ADT (Shanghai) Corporation

FCC ID: RG3WGPS900M01 & RG3WGPS900M02

The following lists are the answers for the comments on Feb. 15, 2006, please kindly have a review on it:

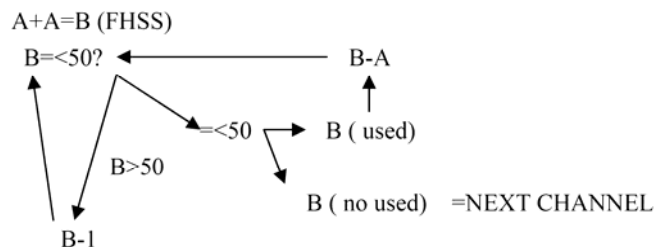
1) It is uncertain why the frequency list does not match the correct range you cited. All information must be correct and match. Please correct as necessary.

RE: Please see user manual. The frequency range is changed to actual one and complied with what the report shows.
